### C. Second Response to Environment Agency

**RE: Stage Brewery – River Wall**

I am writing in response to your comments dated 18<sup>th</sup> September 2018 in relation to the proposals for a new river wall at the Stag Brewery Site (planning reference: 18/0547/FUL). Please see below the information in response to your comments.

## E. Updated Defence Drawings – Ship Lane

SECTION E E - FUTURE

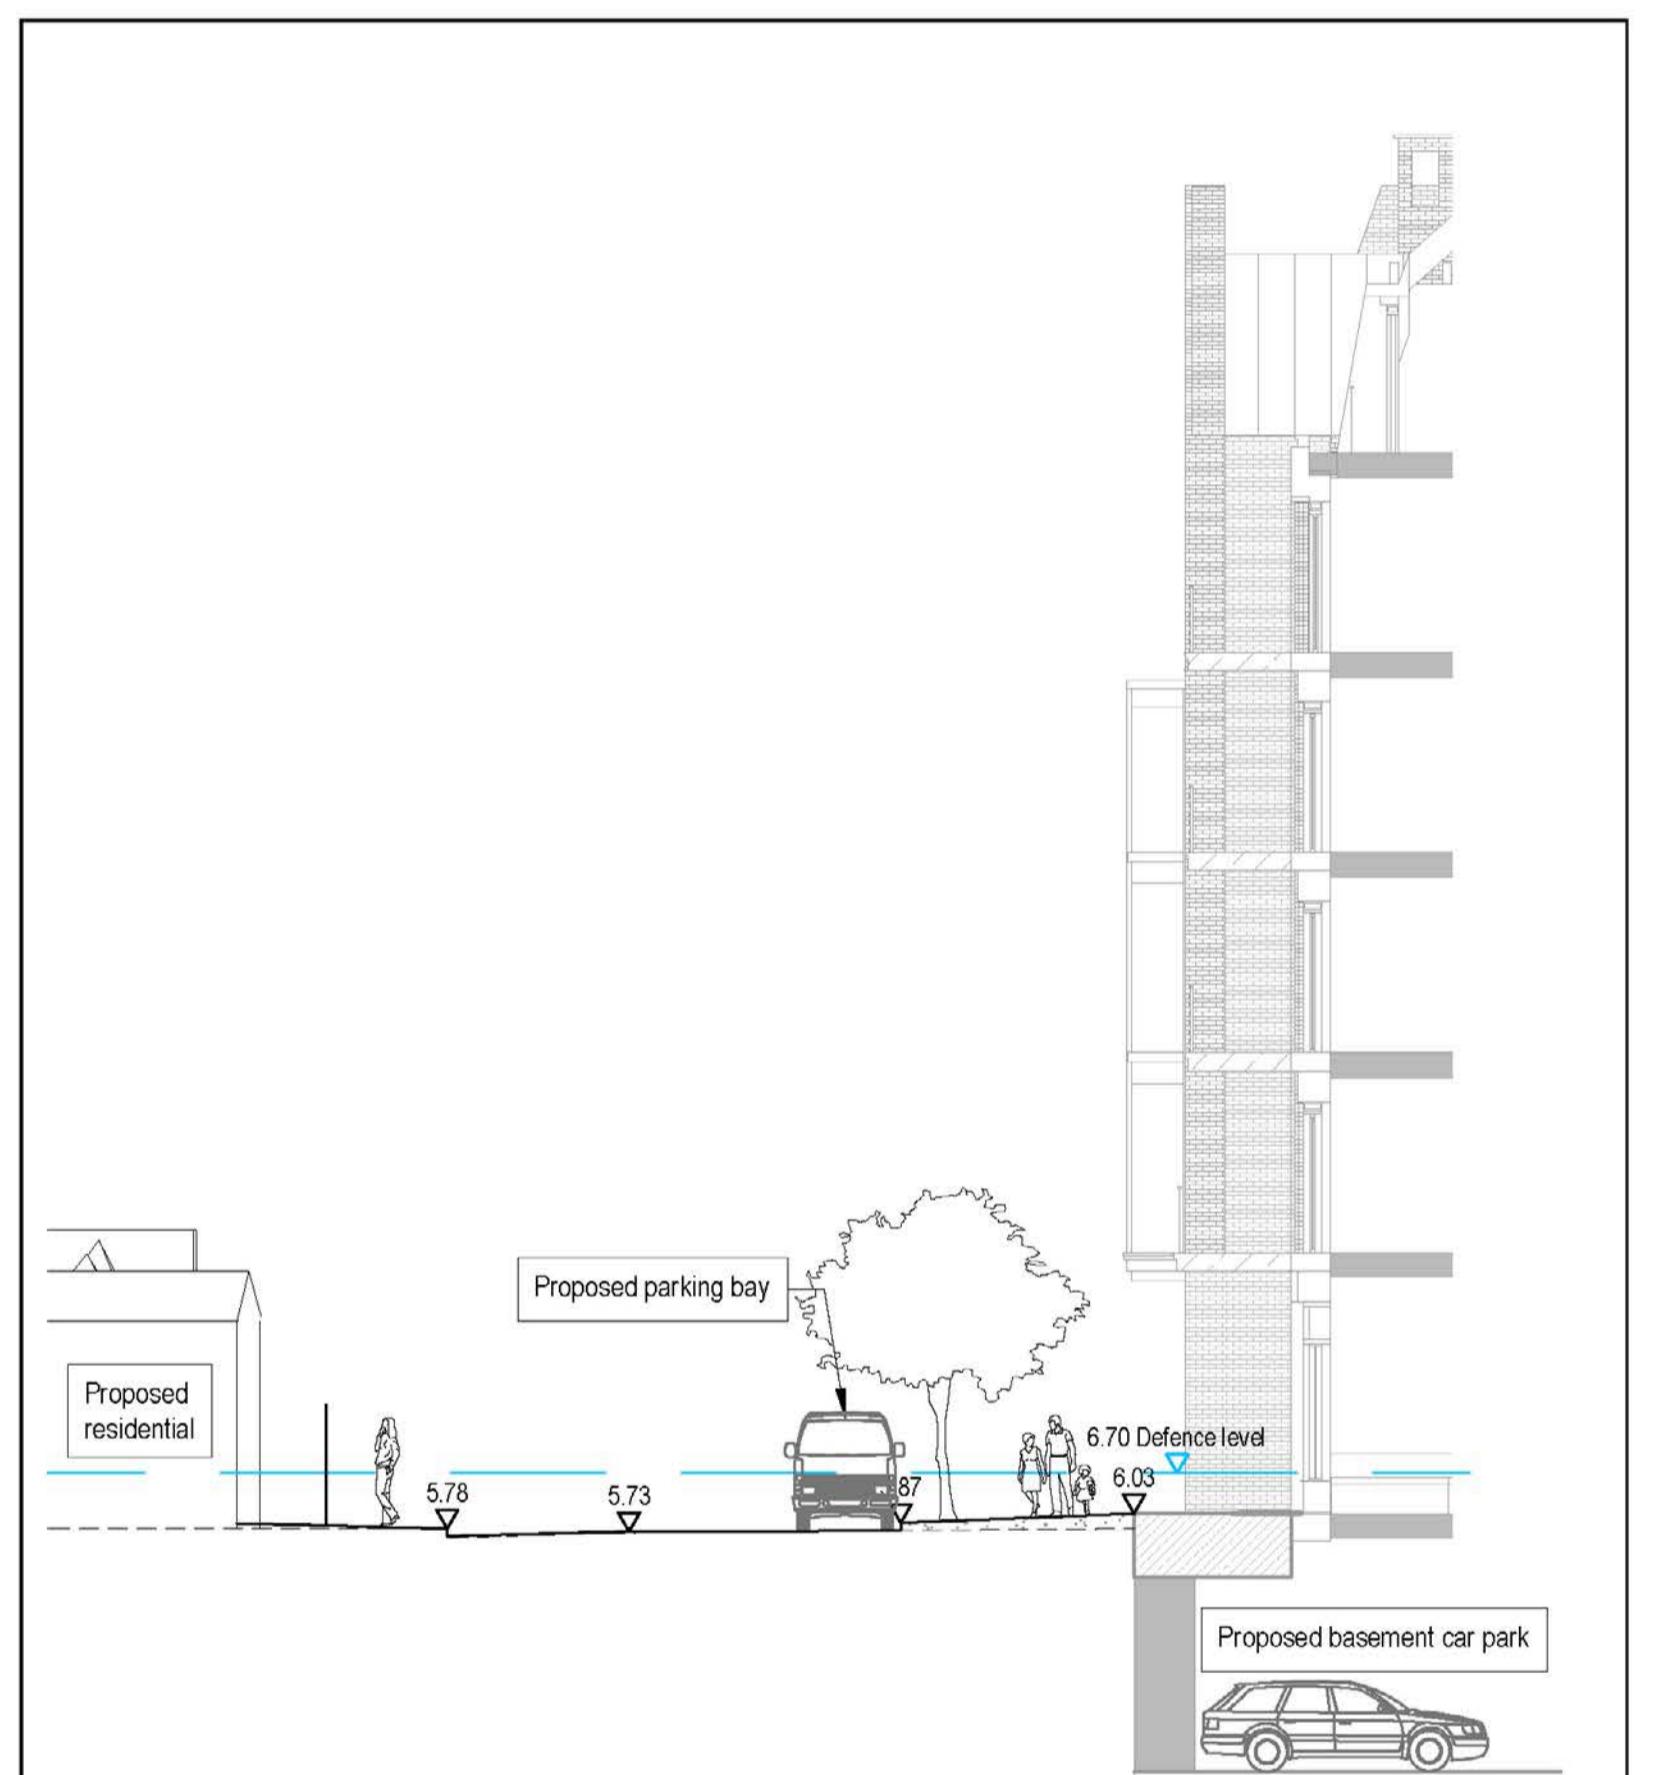
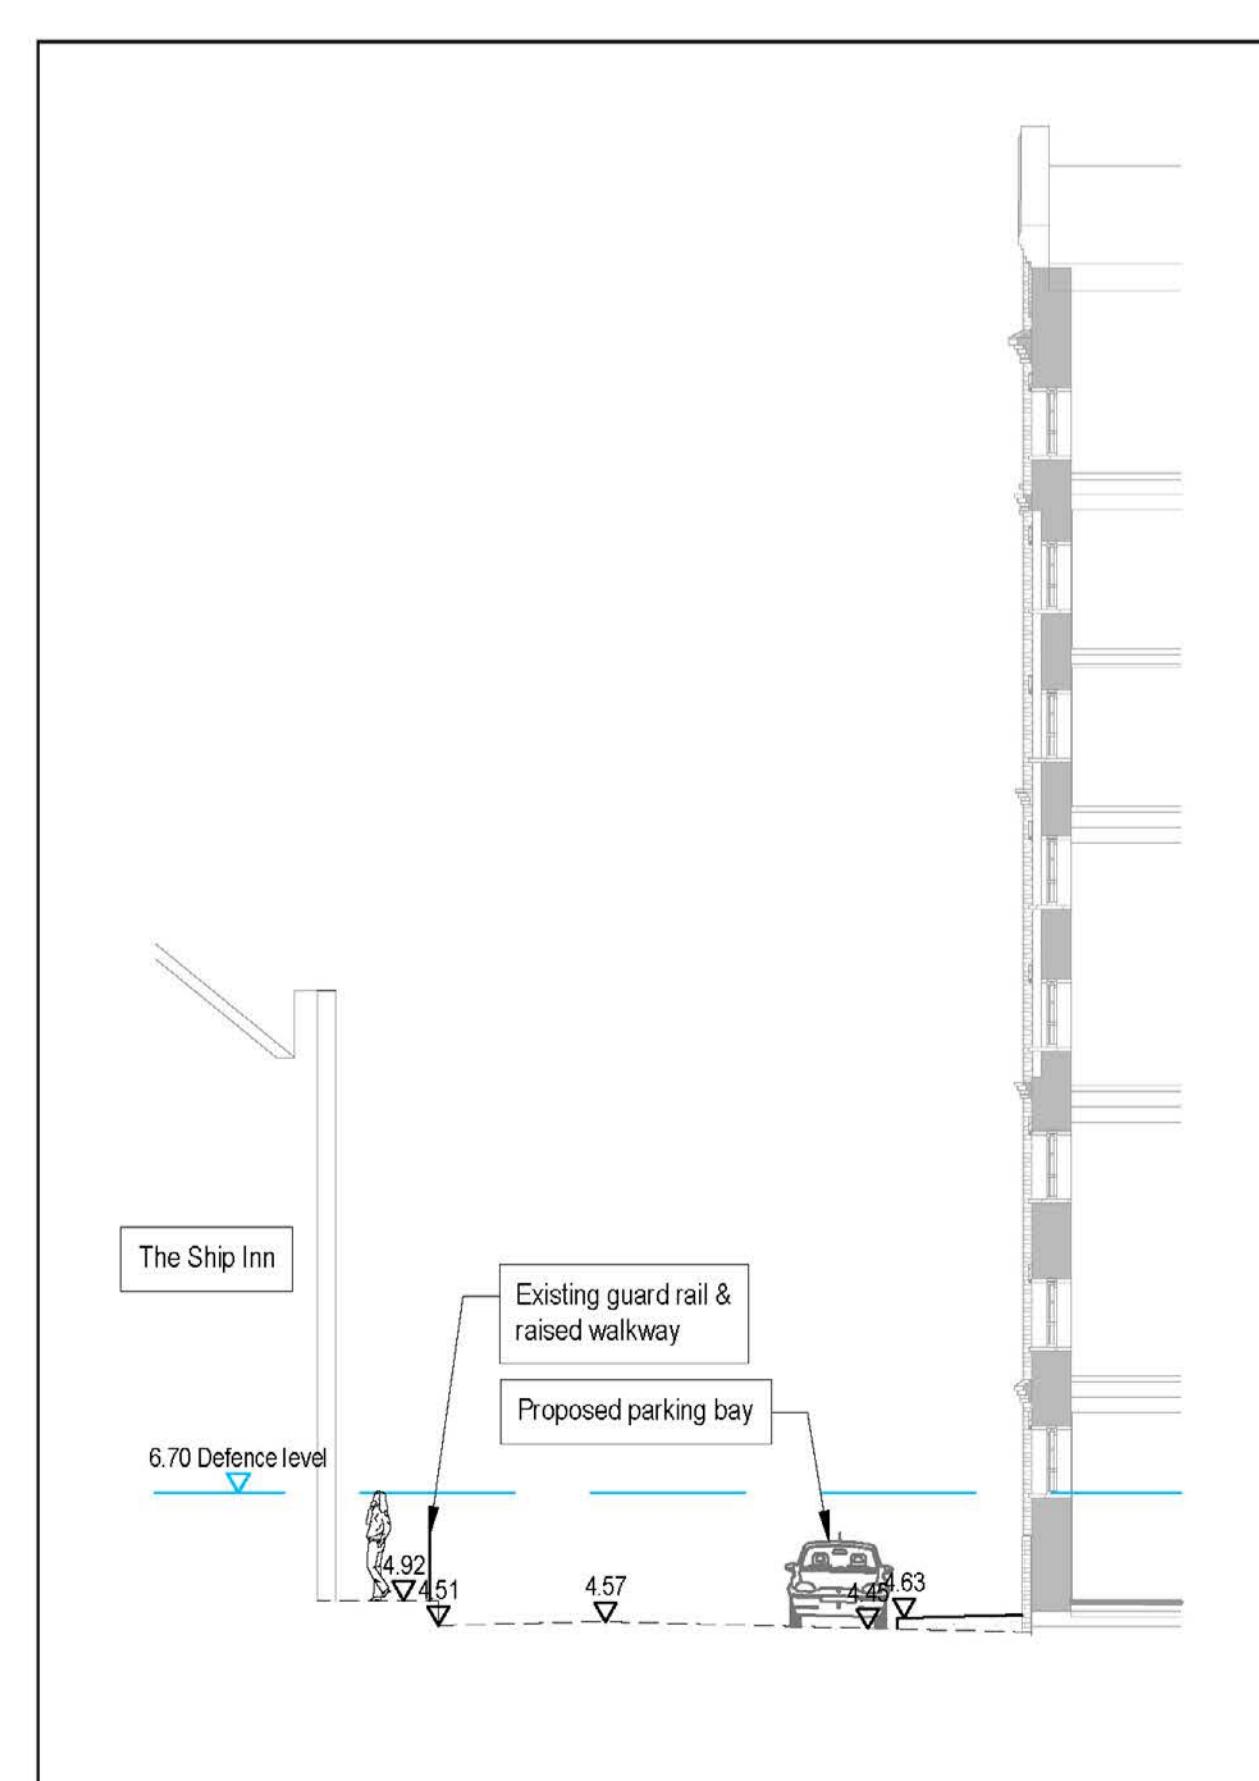
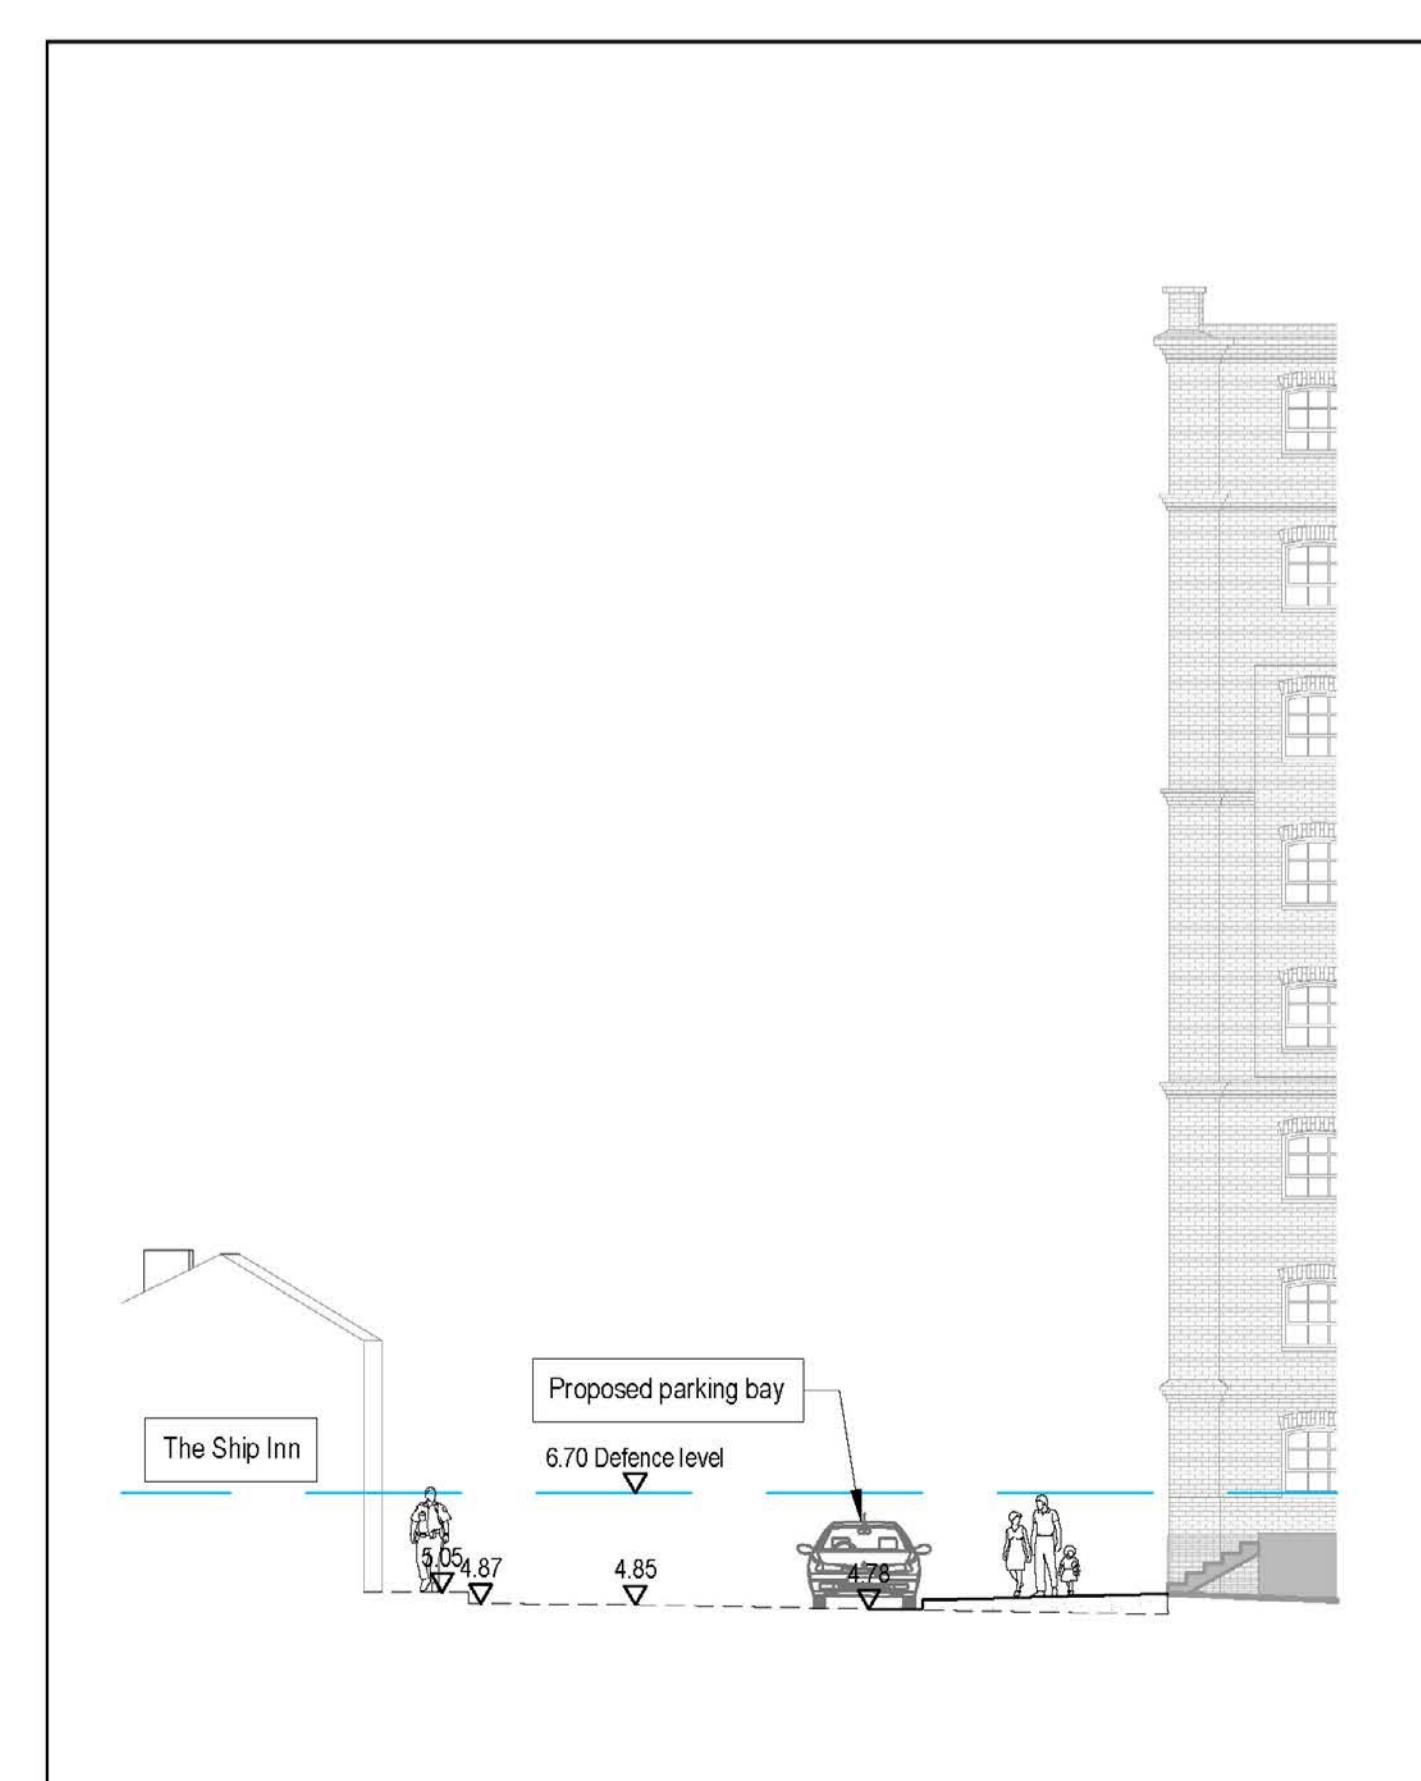
**Query 5) – Ship Lane and Bull Alley** – Bull Alley, and the flood boards for this location are within the redline boundary of the application. Irrespective of ownership, developer will have to demonstrate both the residual lifespan and TE2100 crest level raising for all tidal flood defences within their red-line boundary. Our preference would be for the flood boards to be removed and a passive (static) flood defence installed. Regarding Ship Lane, we appreciate the applicant may not be the freeholder of this land, and therefore may not be liable to ultimately provide the flood defence across the road. However, the applicant is responsible for demonstrating how all flood defence line within their redline boundary, will be treated in light of TE2100 raising requirements and how these will tie in with the

We appreciate that a passive defence is always preferable, however the practicalities of raising Ship Lane itself mean that this option is not suitable. It is correct that the level of Ship Lane does rise to circa 6.1m AOD and that at this point a raise of only 600mm would be required. However, this would result in the River Thames Defence line moving back along Ship Lane in a southerly direction which in turn will allow flood water to flow further down Ship Lane than it would currently do. As a result, the defence height of 6.7m AOD would then need to be in place on either side of Ship Lane. This would render the currently proposed active frontages along Ship Lane unfeasible and would create a narrow corridor with walls on either side.

If constraints mean that passive defences are not possible to the full TE2100 height of 6.7m AOD then the EA would want the height of any gate limited to minimum it needs to be (i.e. raised ground provides protection to say 6.0m AOD and then a gate would only need to be 0.7m high).
